NEBRASKA CAPITOL ENVIRONS COMMISSION STAFF REPORT

APPLICATION NUMBER Urban Design Record #24008
APPLICATION TYPE Certificate of Appropriateness
ADDRESS/LOCATION 220 Centennial Mall S
HEARING DATE January 26, 2024
ADDITIONAL MEETINGS February 25, 2022 and July 28, 2023
APPLICANT Drew Sova, 402-408-0005, dsova@whitelotusgroup.com
STAFF CONTACT Collin Christopher, 402-441-6370, cchristopher@lincoln.ne.gov

Mural Mixed-Use Project Streetscape + Site Screening Design Review

Nebraska Capitol Environs Commission - Project Review
01.26.2022

Mechanical Screenwall

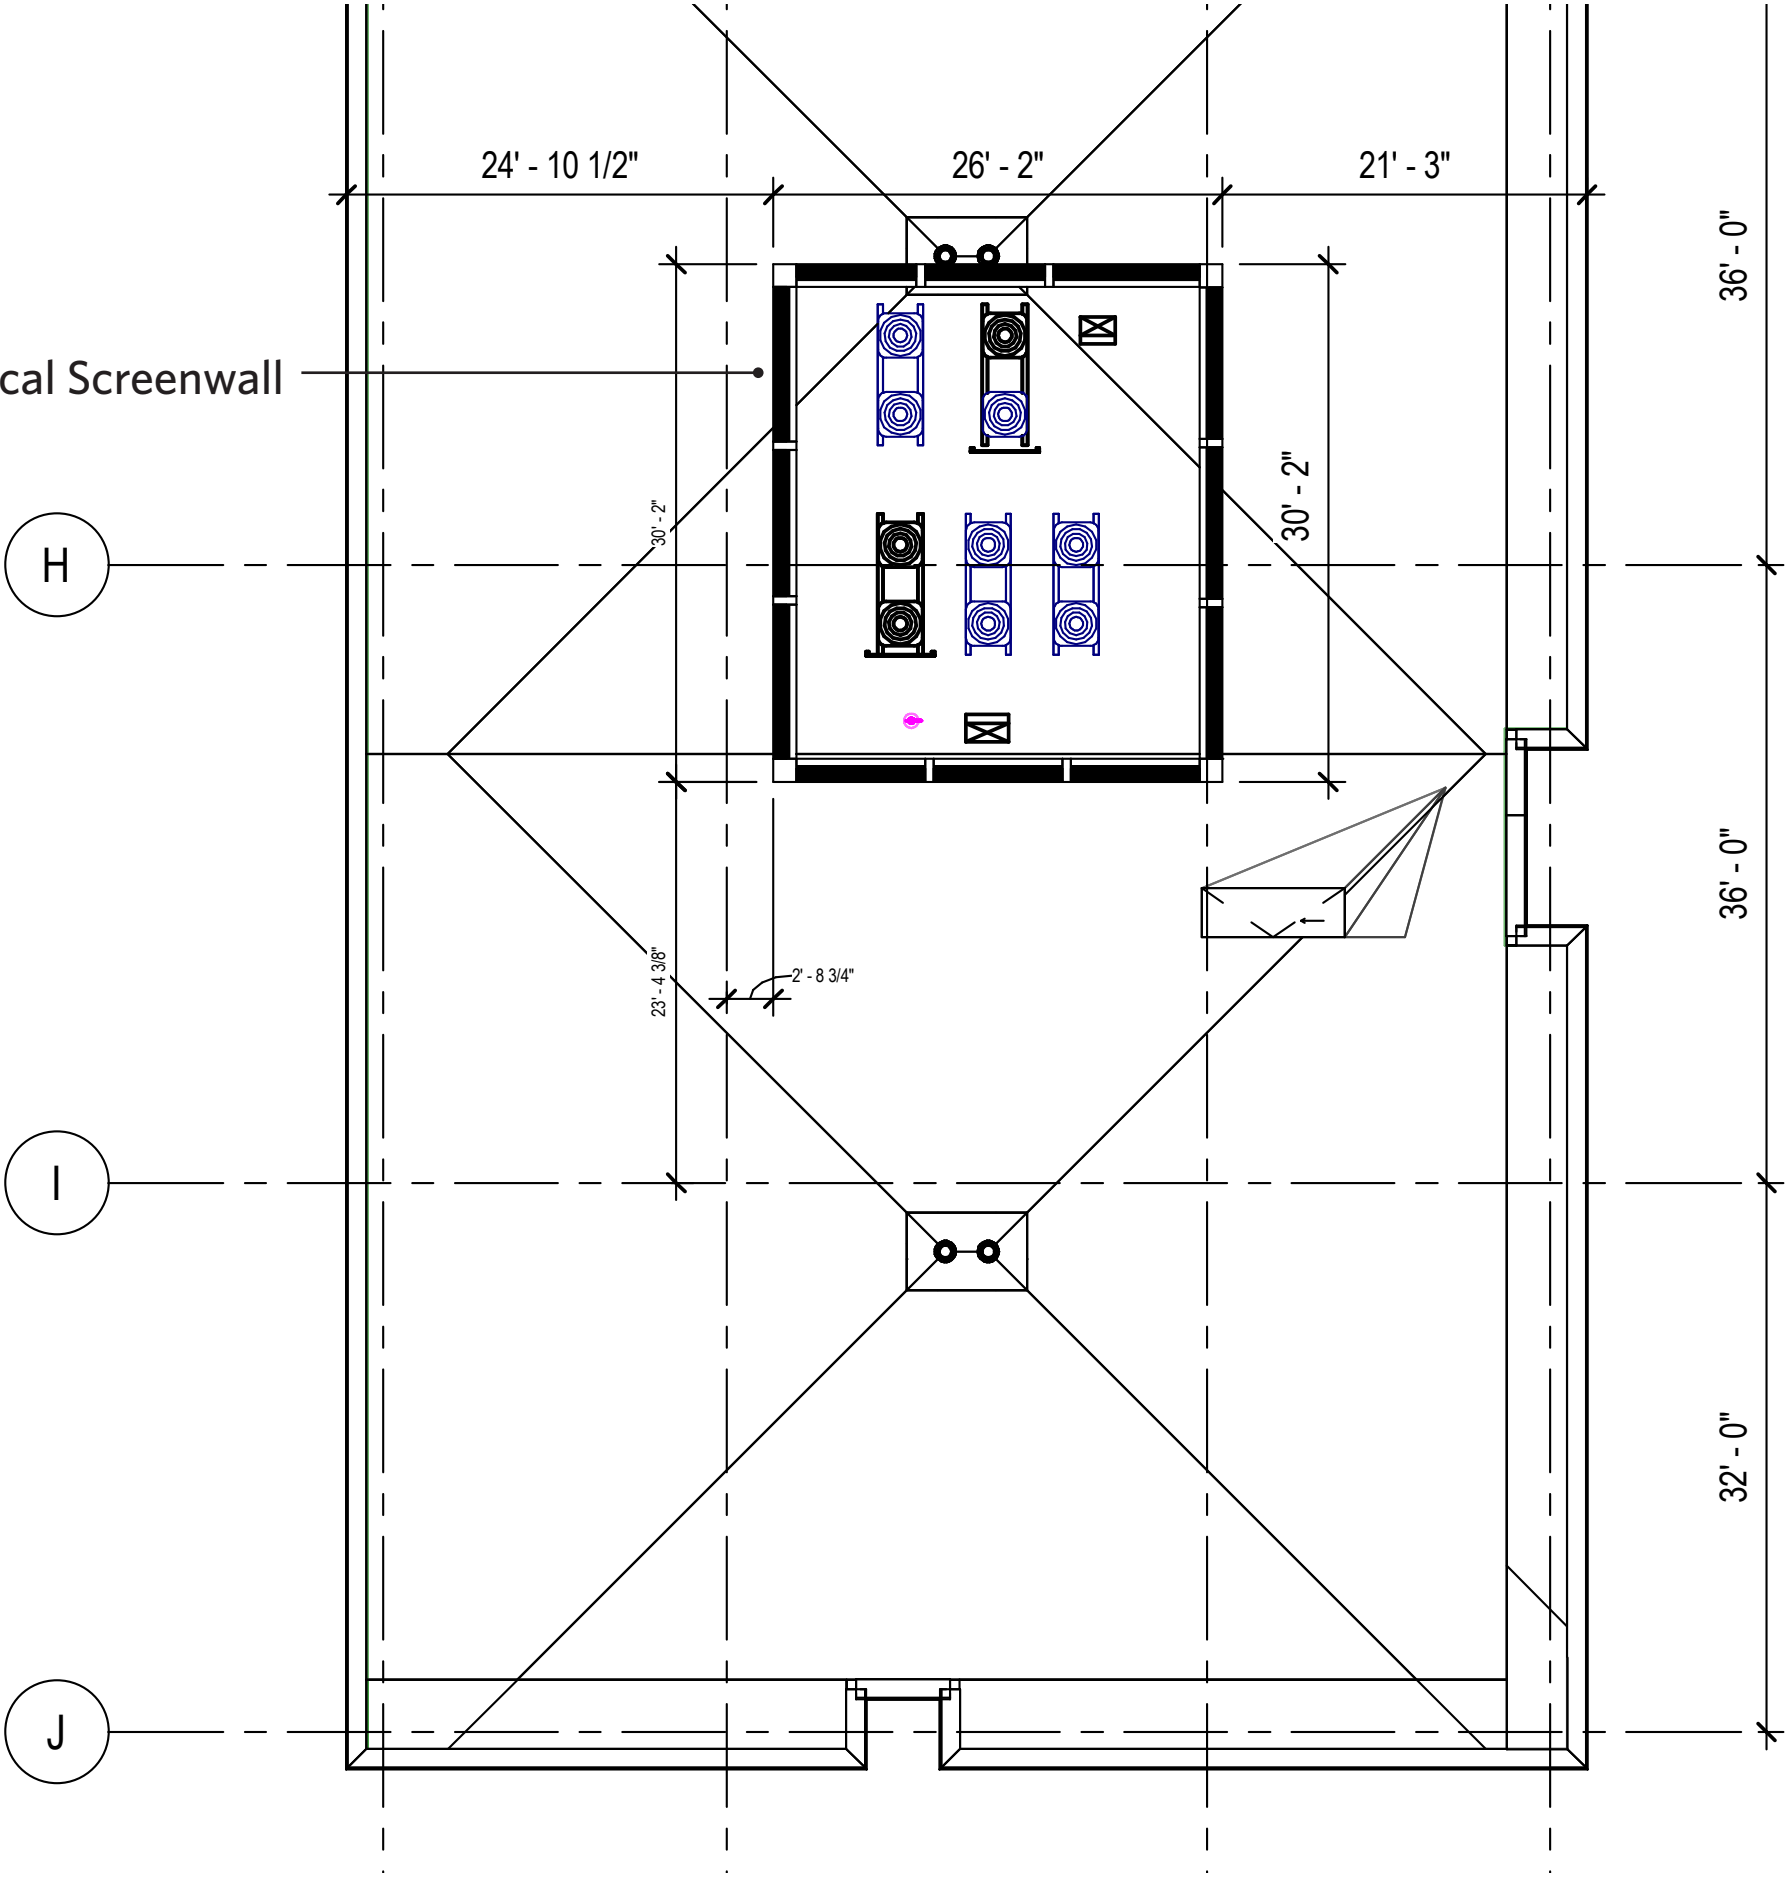
Per the request of the Commission, the applicant has also submitted additional information related to the screening of the rooftop and utility equipment and are asking for a review and approval of that as well.
